City of Fredericksburg

Planning and Zoning Meeting Agenda
Tuesday, July 2, 2024 ~ 5:30 PM
Law Enforcement Center
1601 E. Main Street
Fredericksburg, Texas 78624

PLANNING AND ZONING COMMISSION **AGENDA MEMO**

A Site Plan, Conditional Use Permit (CUP) and Entry Corridor application has been submitted to allow a "drive-through" associated with RBFCU for property located on the Northeast corner of US HWY 87 and Friendship Lane.

1 SITE PLAN
SCALE 1" = 20'-0"

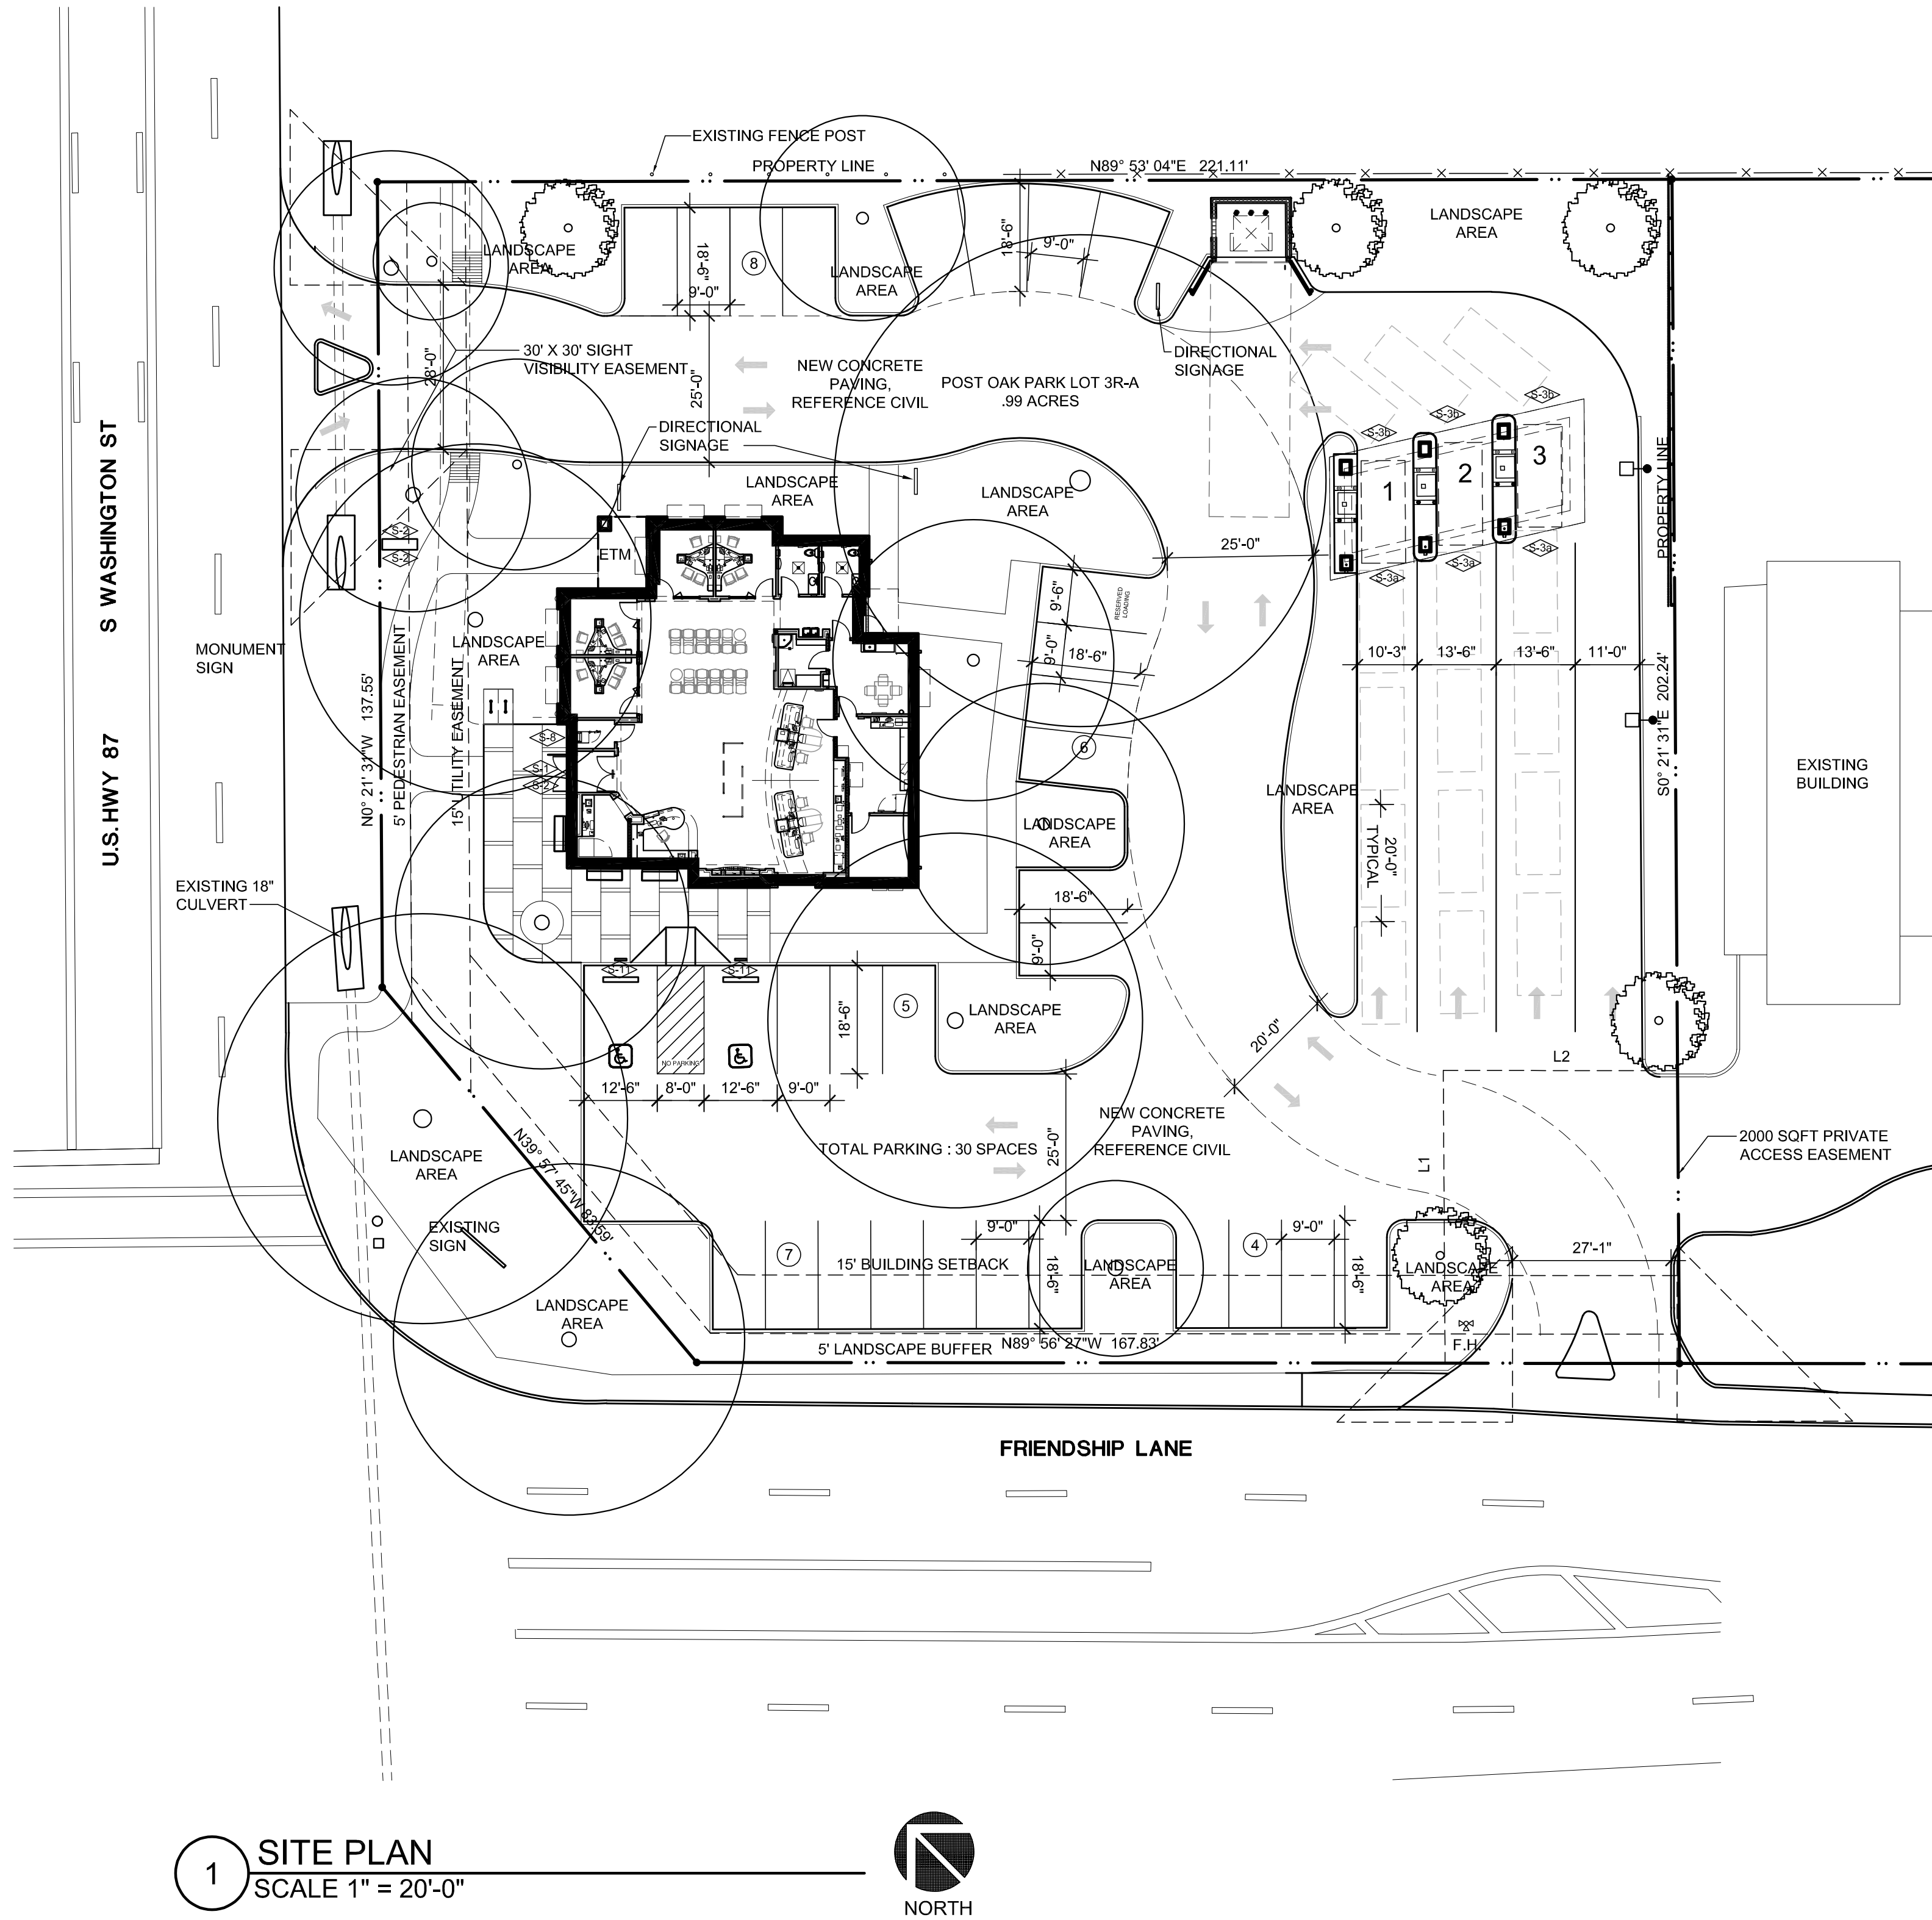
Sidewalk: A sidewalk is provided along the HWY 87 property line. The proposed public sidewalk should remain within the pedestrian access easement as shown on the plat. It can be re-platted to change the alignment of the easement however, the sidewalk alignment should return to the edge of the right-of-way at the northern property line so that the next property can continue it from there.

Parking: 1 parking space per 400 sq ft is required for a total of 8 spaces. The applicant has chosen to provide 30 spaces to accommodate bank customers. Staff does not support the over parking with the additional 22 parking spaces. Staff suggests reducing to increase pervious area. [Sec. 7.864](#)

1. Approved Civil Construction Plans
2. Relocation of the Public Sidewalk within the pedestrian access easement and alignment with the edge of the right-of-way at the northern property line.
3. TxDOT permit for the HWY 87 driveway
4. Reduction in proposed parking

The sidewalk has been adjusted to run within the pedestrian easement and connect to the existing sidewalk in the southwest corner of the property. A portion of the sidewalk veers out to the pedestrian easement in order to avoid existing trees on the site.

1 WEST ELEVATION - FACING U.S. HWY 87 (S. WASHINGTON ST.)
SCALE: 1/4" = 1'-0"

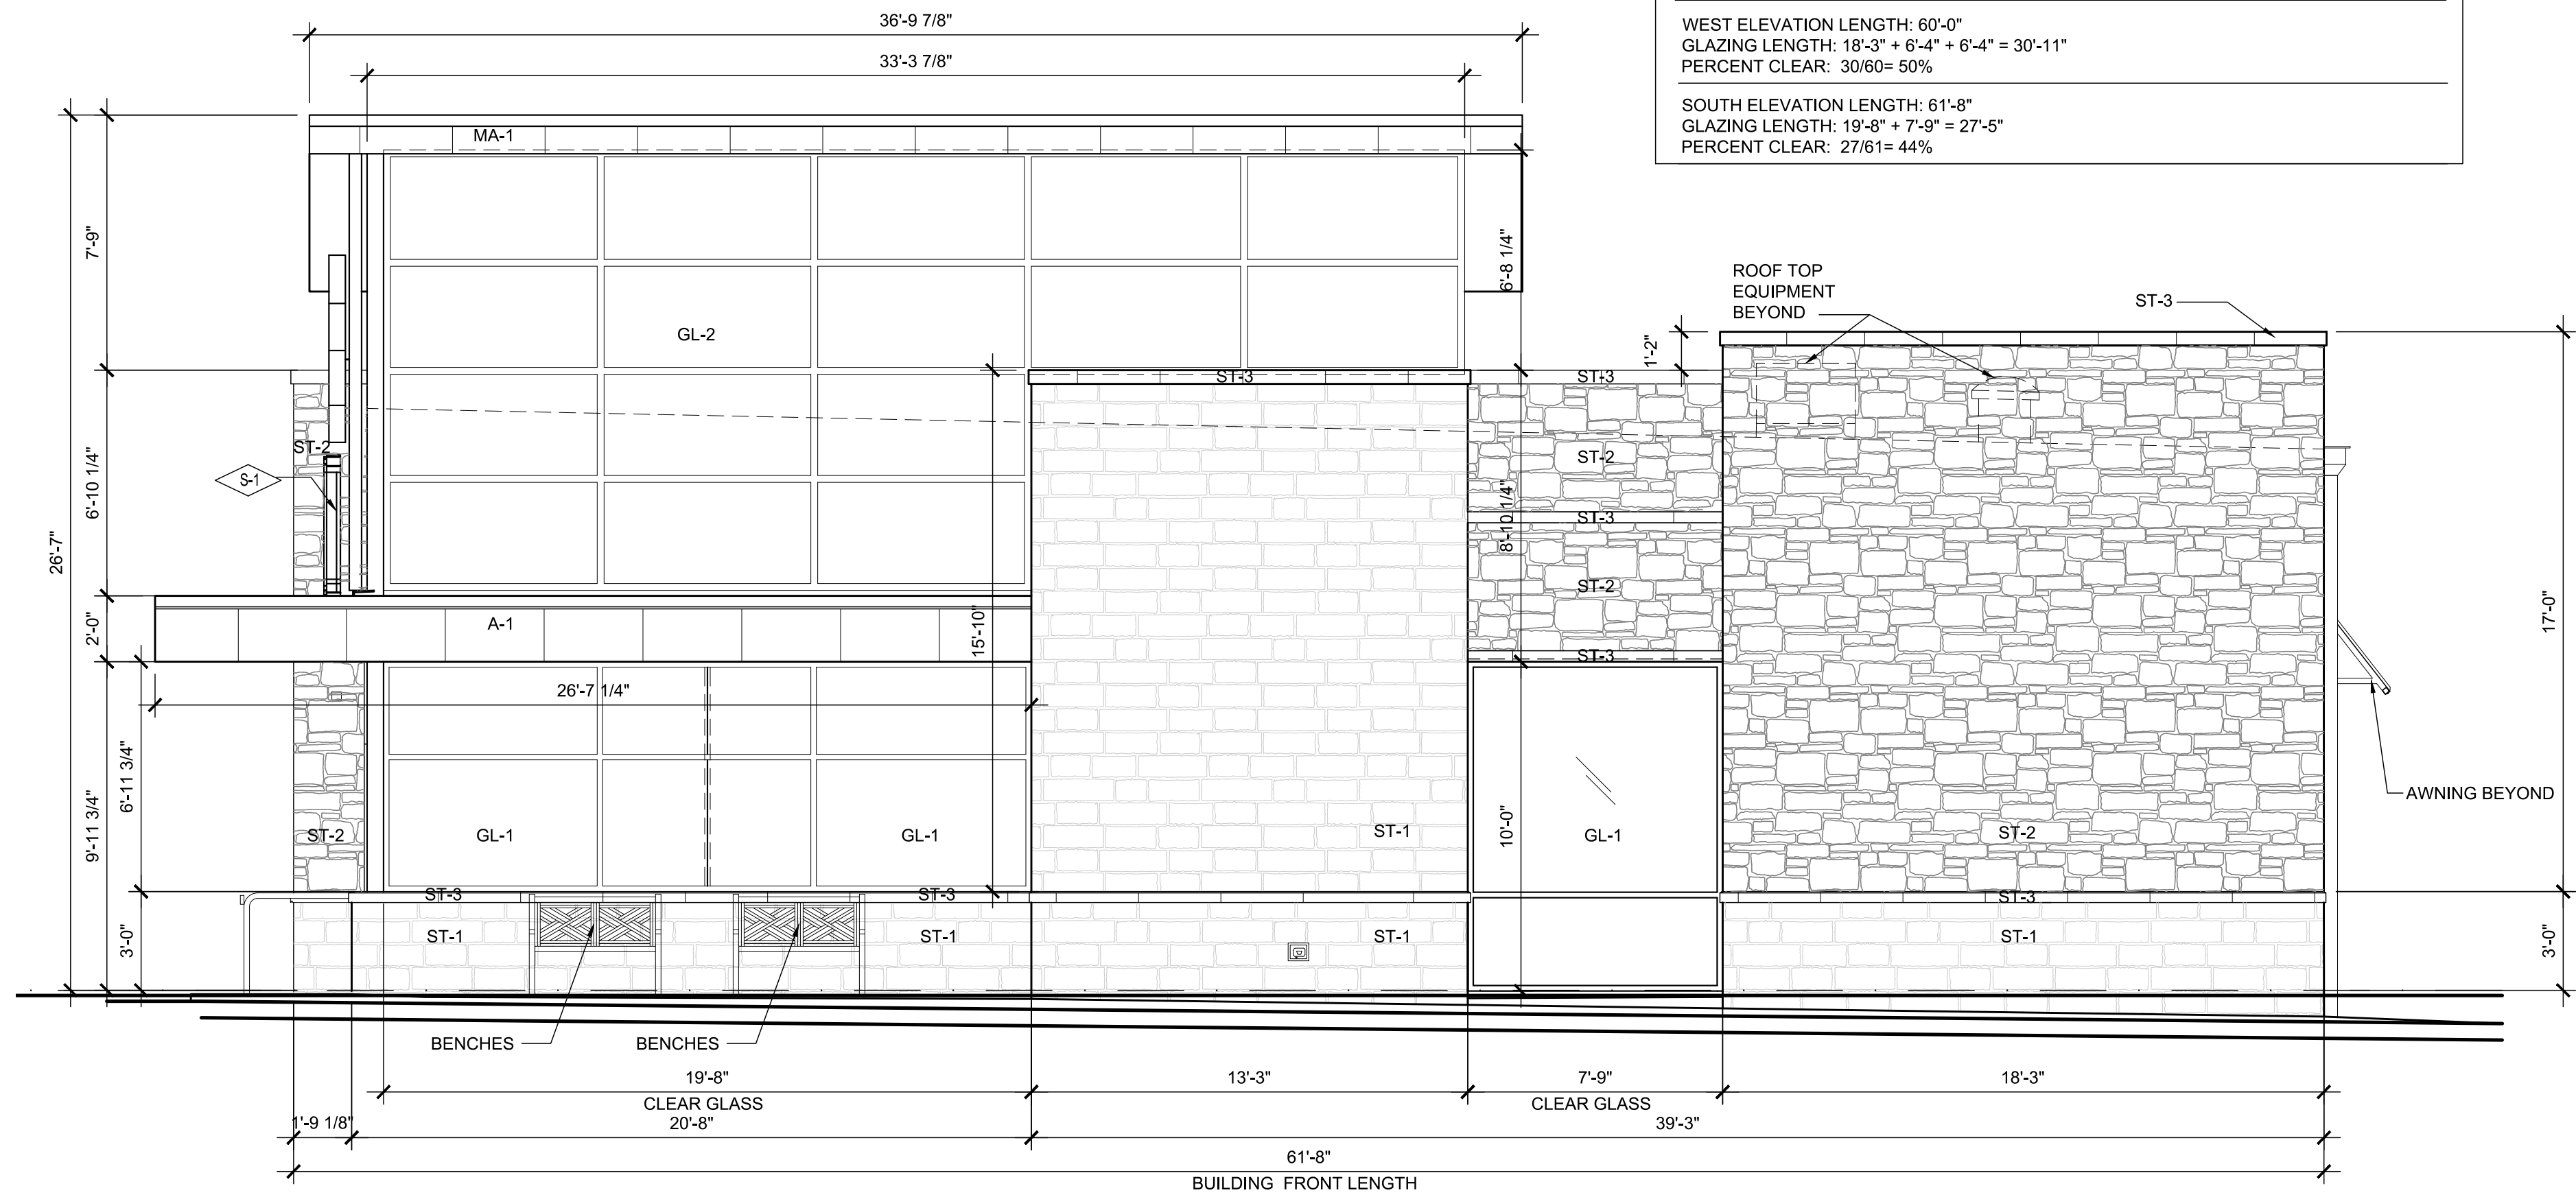
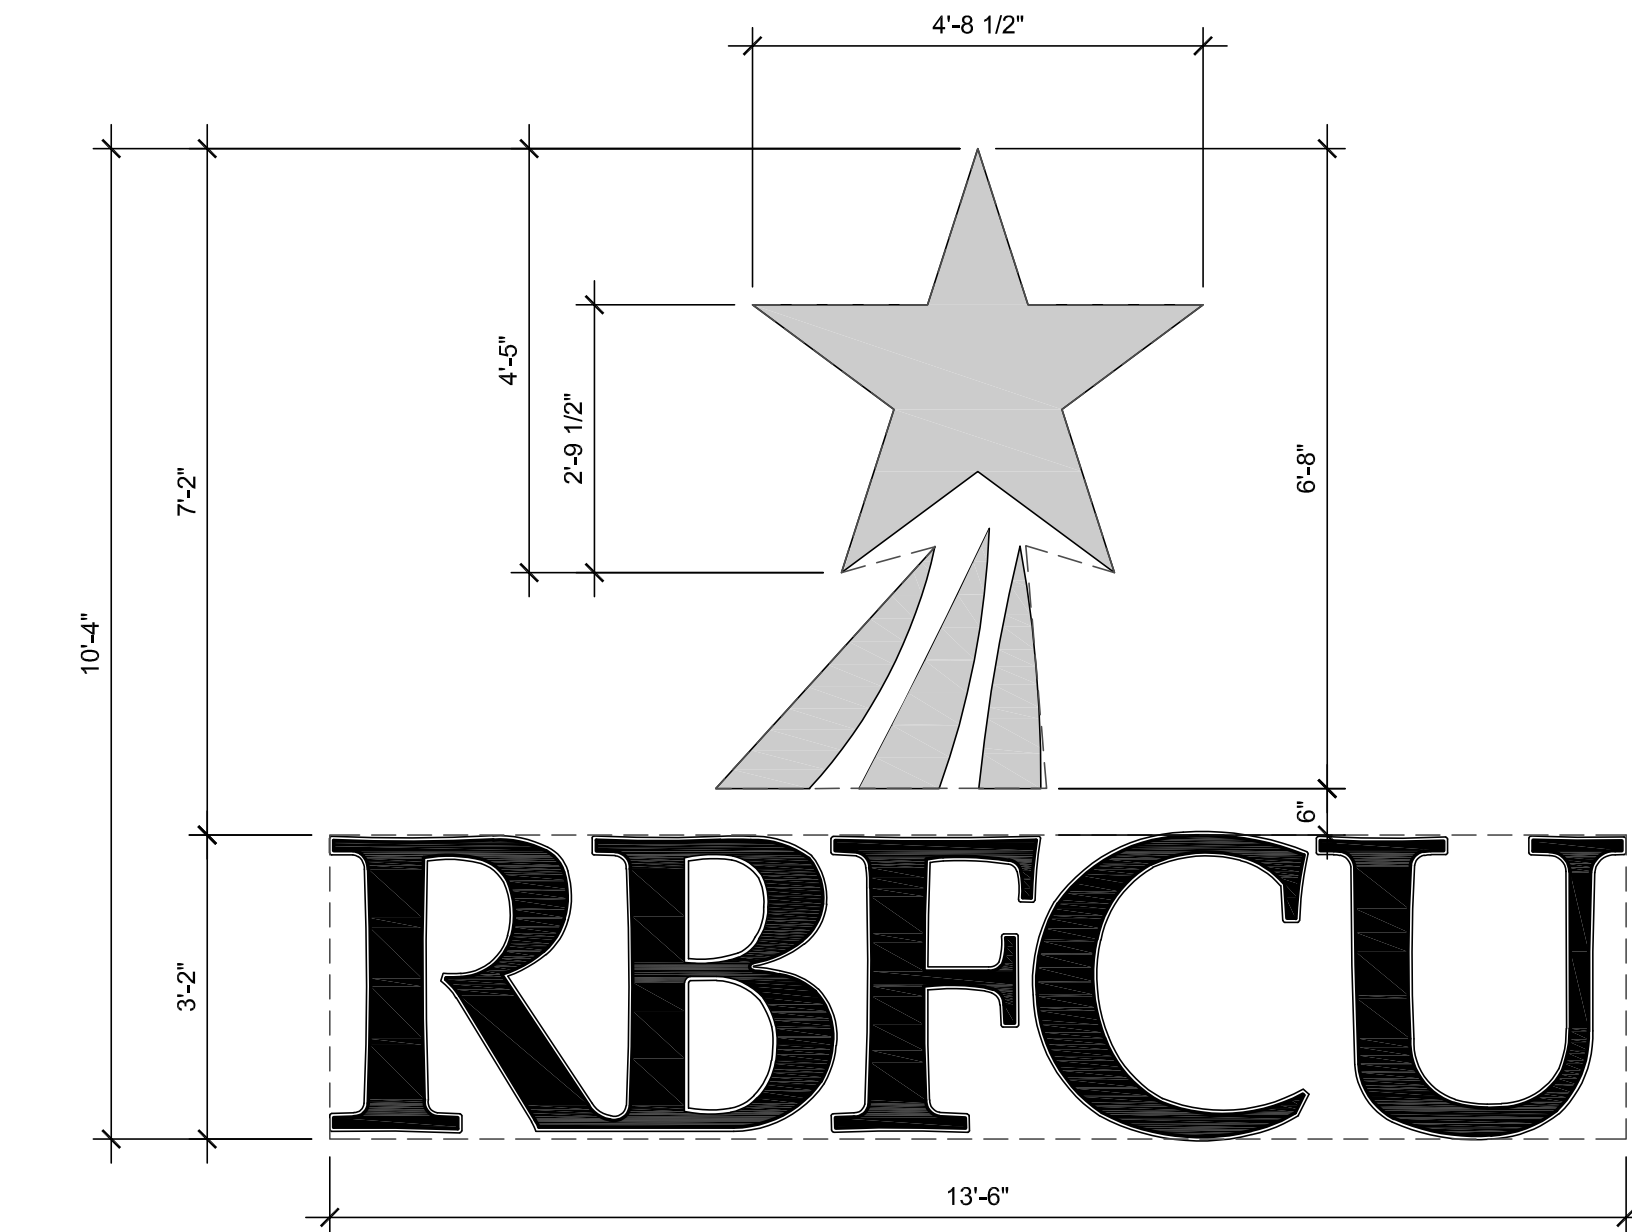
WEST ELEVATION LENGTH: 60'-0"
GLAZING LENGTH: 18'-3" + 6'-4" + 6'-4" = 30'-11"
PERCENT CLEAR: 30/60= 50%

SOUTH ELEVATION LENGTH: 61'-8"
GLAZING LENGTH: 19'-8" + 7'-9" = 27'-5"
PERCENT CLEAR: 27/61= 44%
